MFN 08-011

Subject: Response to Portion of NRC Request for Additional Information Letter Nos. 33 and 68 Related to ESBWR Design Certification Application - Containment Systems - RAI Numbers 6.2-56 S01 and 6.2-98 S01

Response to Portion of NRC Request for Additional Information Letter Nos. 33 and 68 Related to ESBWR Design Certification Application

RAI Numbers 6.2-56 S01 and 6.2-98 S01

Figure 6.2-98S01-2. DCD TRACG Nodalization of the ESBWR Containment

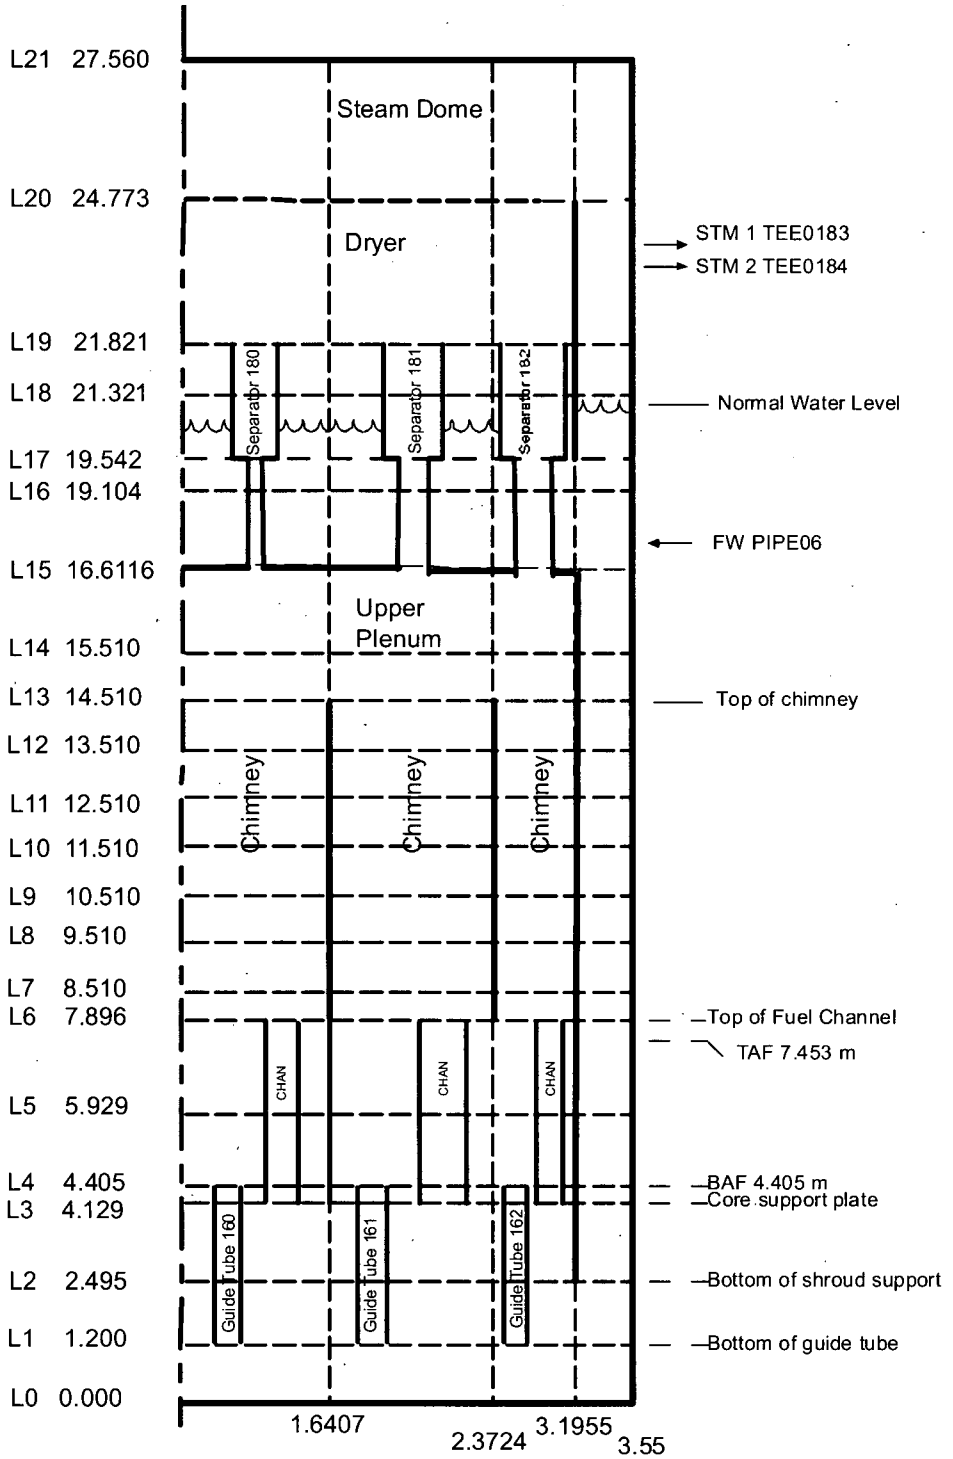
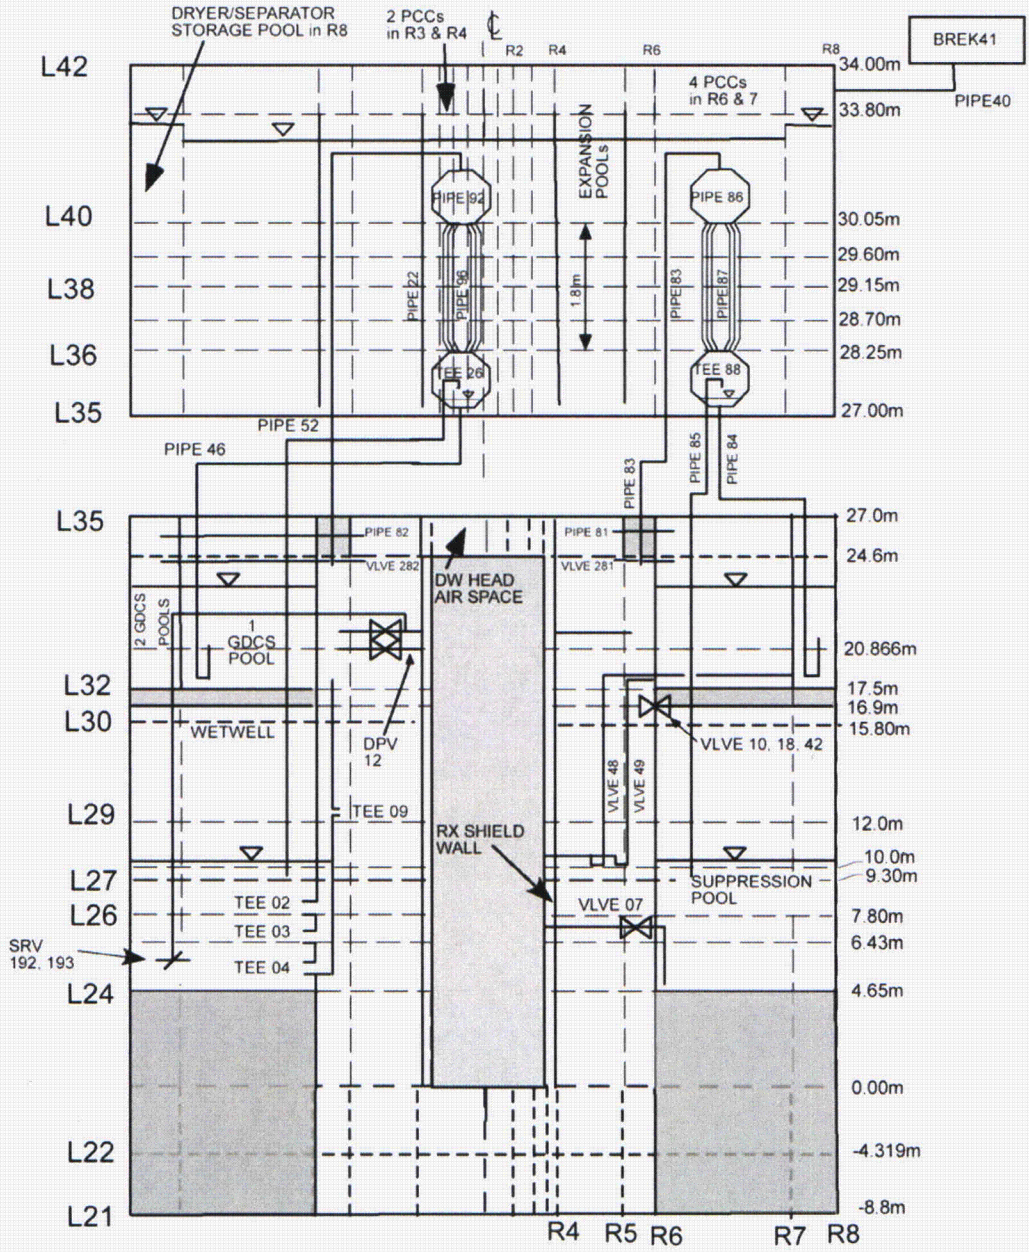
(D) After the opening of the DPVs, the long-term containment responses from FWLB accident to MSLB accidents are expected to be similar. However, the results show that they differ. Please (1) identify and justify the nodalization differences between FWLB and MSLB accidents and (2) explain the differences in results.

Referring to the TRACG nodalization (Figures 6.2-98S01-1 and 6.2-98S01-2), the broken main steam line is located at Level 34 and discharges steam into the drywell (DW) at this elevation. Two pipes (per Gravity-Driven Cooling System (GDCS) airspace) are used to simulate the connection between the GDCS pool airspace and the DW (Figure 6.2-98S01-2), to purge the residual non-condensable (NC) gases in this airspace. For the NC gases, the nitrogen properties are used in these TRACG calculations.

Two pipes (per GDCS airspace) are used to simulate the connection between the GDCS pool airspace and the DW (Figure 6.2-98S01-2). This nodalization is selected to minimize the NC gas holdup in the DW head and GDCS pool airspaces. Parametric studies (using MSLB case) were performed earlier (response to RAI 6.2-53 S01, MFN 02-215, Supplement 1) to evaluate the effectiveness of the double pipe connection. The results show that there are essentially no NC gases remaining in the DW head and GDCS airspaces for the MSLB with double pipe connection. The current results (Paragraph A1.4 in this response) also show the same effect on the purging of NC gases.

The MSLB and the FWLB use the same nodalizations for the RPV and containment (Paragraphs A1.1 and A2.1). The differences between these two cases are the modeling of the break pipes (DCD Tier 2, Revision 4, Figure 6.2-8 for MSLB and Figure 6.2-8b for FWLB).

Figure 6.2-98S01-3. Containment Pressure Response (72 Hours)
(MSLB: MSL4A_1DPVCB-72)

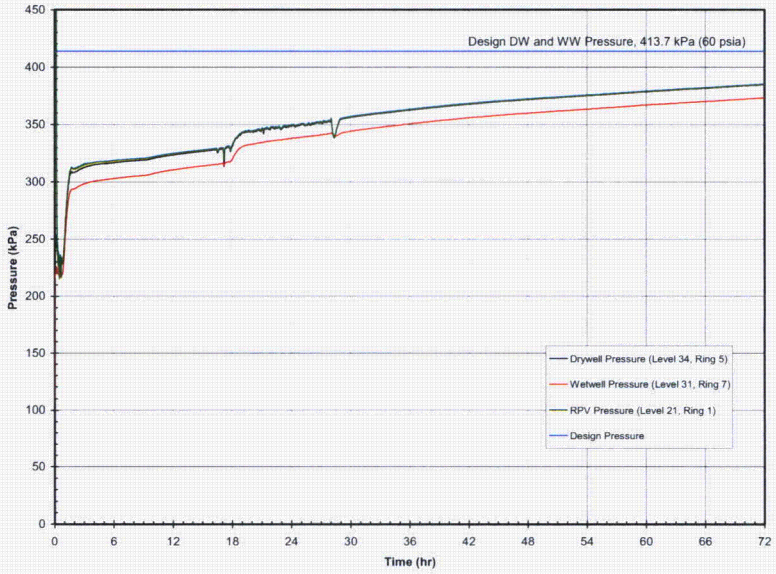
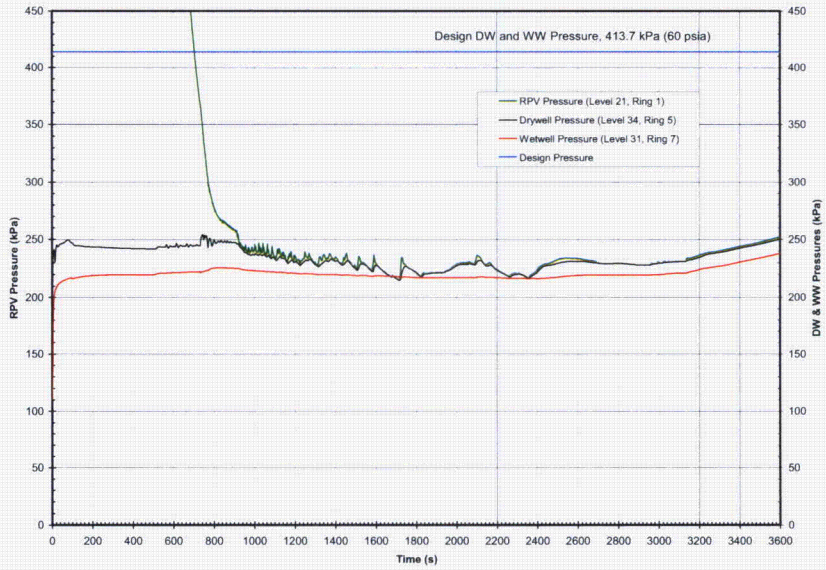
(A) The limiting design basis accident changed from feed water line break (FWLB) to main steam line break (MSLB) as given in ESBWR DCD Tier 2 Revision 3. As a result, in RAI 6.2-141, the staff requested GEH to revisit RAIs that were affected by this change, specifically RAI 6.2-98. However, the GEH's response to RAI 6.2-98 was based only on the FWLB accident. The analyses results of the FWLB accident are important because of their closeness to that of the MSLB accident and the fact that FWLB is the second limiting accident. Please provide the analyses results of the MSLB accident.

Figure 6.2-98S01-3 shows the reactor pressure vessel (RPV), DW and wetwell (WW) pressures, and Figure 6.2-98S01-3a shows the same responses in short-term time scale.

Following the postulated loss-of-coolant accident (LOCA), the DW pressure increases rapidly leading to the clearing of the Passive Containment Cooling System (PCCS) and main vents. At approximately 79 seconds, the DW pressure reaches a peak value of 250 kPa (36.3 psia). This peak pressure is below the design pressure of 413.7 kPa (60 psia) with large margin. During this blowdown period, a significant amount of NC gas is purged into the WW and pressurizes the WW. The RPV continues to depressurize due to the break flow and the Automatic Depressurization System (ADS) flows. At approximately 0.2 hours, the RPV pressure drops below the pressure point at which the GDCS water is allowed to inject into the downcomer by gravity head. The subcooled GDCS water continues flowing into the RPV and reduces the steaming from the RPV and the DW pressure. At approximately 0.48 hours, the DW pressure drops below the WW pressure, causing the openings of vacuum breakers and allowing some NC gases to flow back into the DW. Consequently, the system pressures drop to a value of approximately 217 kPa.

Subsequently, the decay heat overcomes the subcooling of the GDCS water and steaming resumes (at ~0.66 hours, Figure 6.2-98S01-3a). The resumption of RPV steaming causes the DW pressure to increase again starting from 0.66 hours.

Figure 6.2-98S01-12. DW Head NC Gas Pressures
(Level 35 = DW Head)
(72 Hours)
(MSLB: MSL4A_1DPVCB-72)

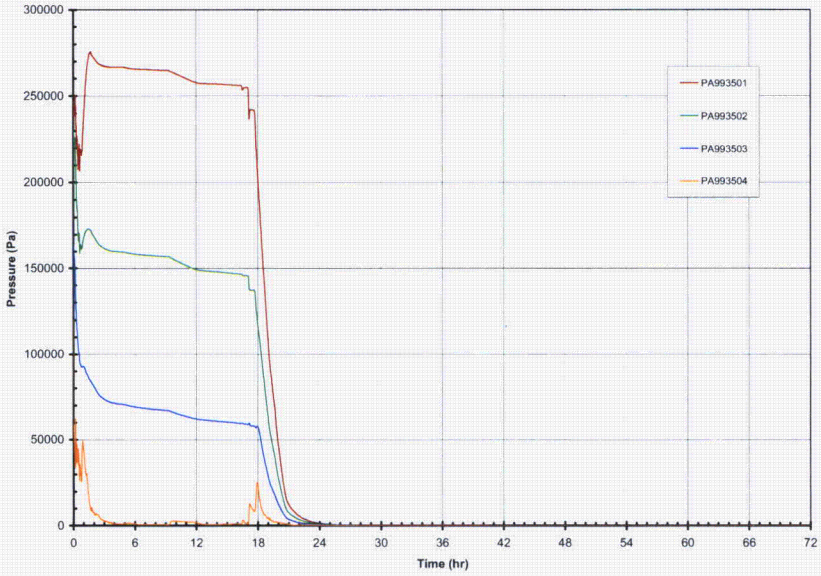
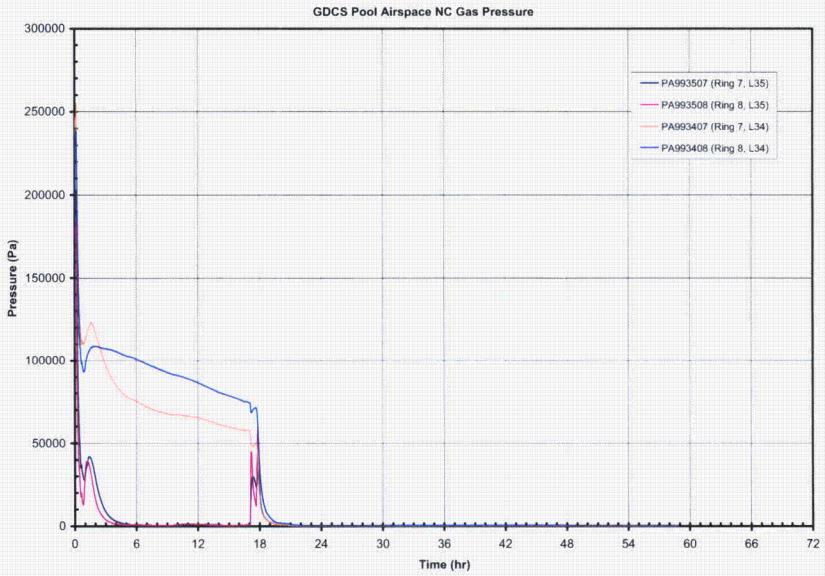
(C) As shown on Figure 6.2-98-5, the noncondensable gas holdup in the drywell head region at 72 hours resulting in a pressure of 50 KPa is significant. Please (1) provide the mass of noncondensables held up in the drywell head region and (2) quantify the effect on the drywell pressure, if the noncondensables held up in the drywell head and GDCS pools were transferred to the wetwell.

Figures 6.2-98S01-9 through 6.2-98S01-13 show the NC gas pressures in the DW annulus, lower DW, air gap between the RPV and the reactor shield wall, the DW head airspace, and the GDCS pool airspace. Most of the initial NC gases in the DW annulus are purged into the WW within 3 hours. It takes approximately 24 hours to purge most of the NC gases in the DW head airspace (Figure 6.2-98S01-12). It takes approximately 20 hours to purge most of the NC gases in the GDCS pool airspaces (Figure 6.2-98S01-13).
